**Review of Landscape and Visual Impact
Proof of Evidence of
Mark Cooper BA(Hons) DipLD CMLI**

Land East of Warwick Road, Banbury

Planning Inspectorate No. APP/C3105/W/24/33382111

30th April 2024

Photoviewpoint EDP 6: PRoW 239/8/20

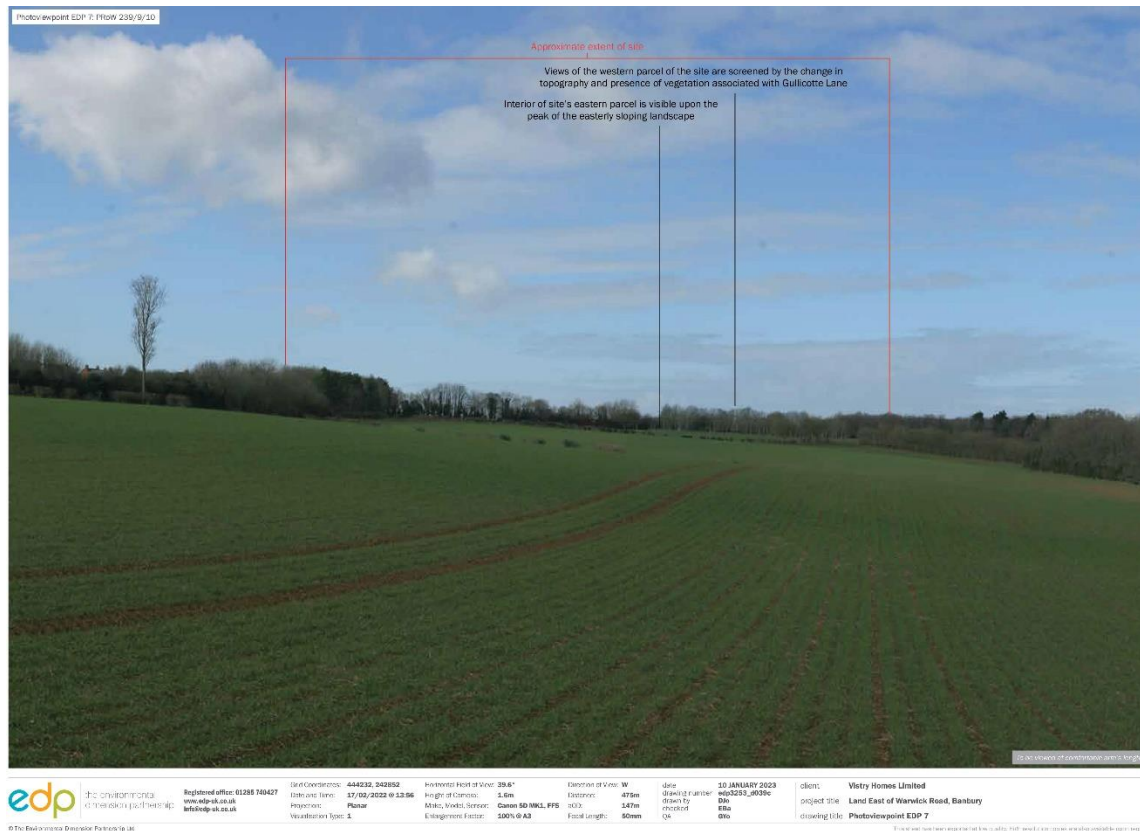
Photoviewpoint EDP 6 also illustrates a worst-case scenario, without leaves in February, when the silhouetted roof-line of properties in Hanwell Fields is visible. Parcel B is visible in this view but Parcel A is concealed beyond the trees of Gullicote Lane on the right. The roof-line of proposed 2.5 storey houses set-back from the Parcel A boundary may be **just** visible in this worst-case view.

ES LVA Chapter 7 Clauses 7.172-7.179 describes the sensitivity of users of PRoW 239/8/20 as **‘High’**, the magnitude of change **‘Medium’** and the indirect, permanent, medium-term adverse effect will be **‘Moderate’** with a **‘Not Significant’** residual effect.

Above – An image from the same location in July 2022 showing the impact of summer foliage.

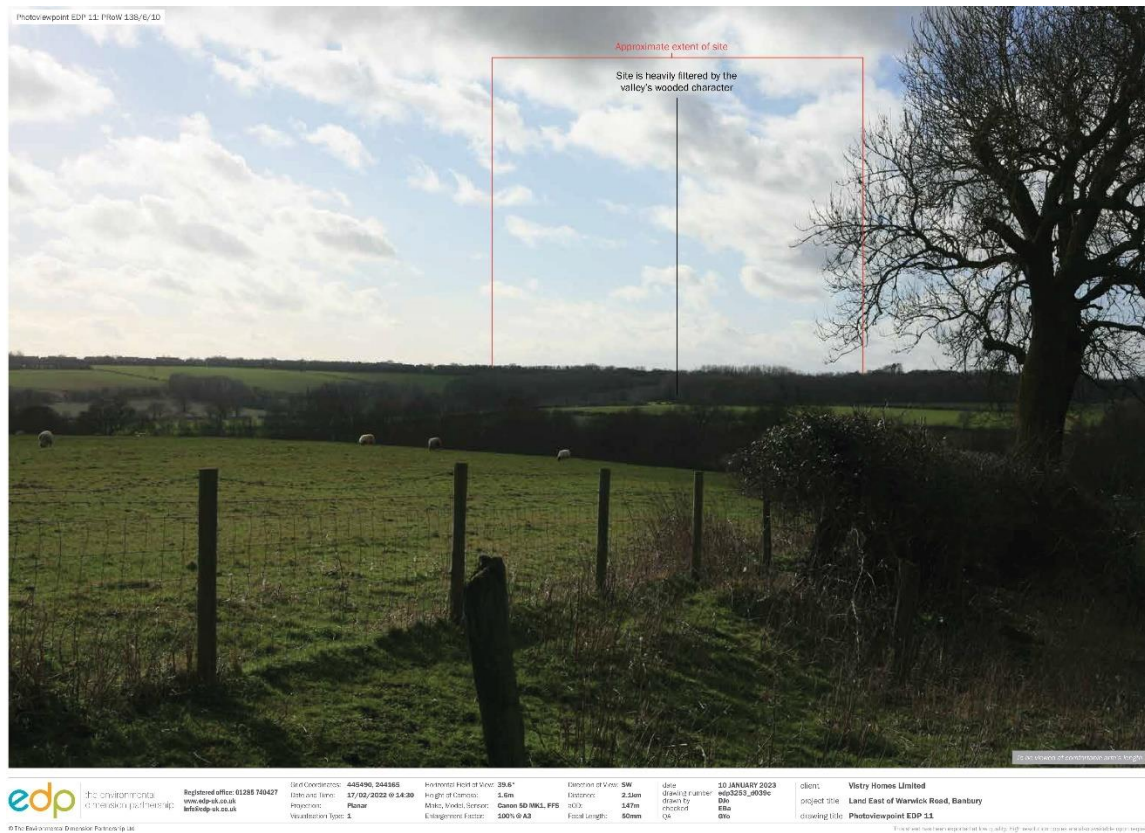
Above— Photoviewpoint EDP 9 is annotated to emphasise the clear views of Parcel A's interior in this 'worst-case' view even with the northern boundary trees which, in February, only serve to filter the view.

Above – An image taken in July 2023 at 2km distance, from the public road north-east of Hanwell, south-west of Great Bourton, shows that the woodland around Hanwell village and the topography of the ridge-line obscure views of either Parcel A or B and would similarly hide buildings on Parcel A.

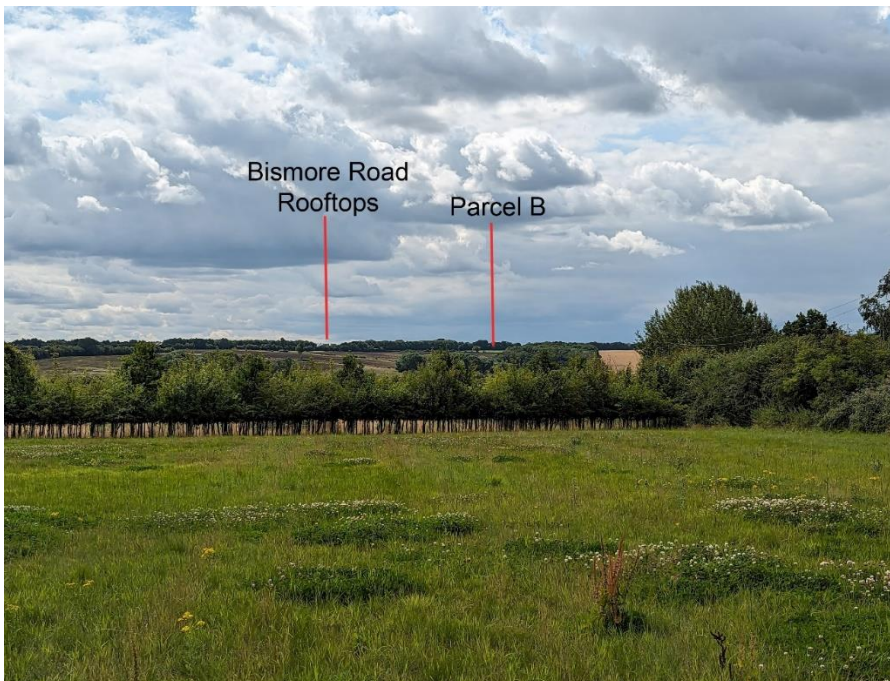
Above – This image taken from close to Little Bourton 2km north-east of the site shows that the site location is not currently definable by eye and that the proposed houses on Parcel A would not be visible even during the winter months.
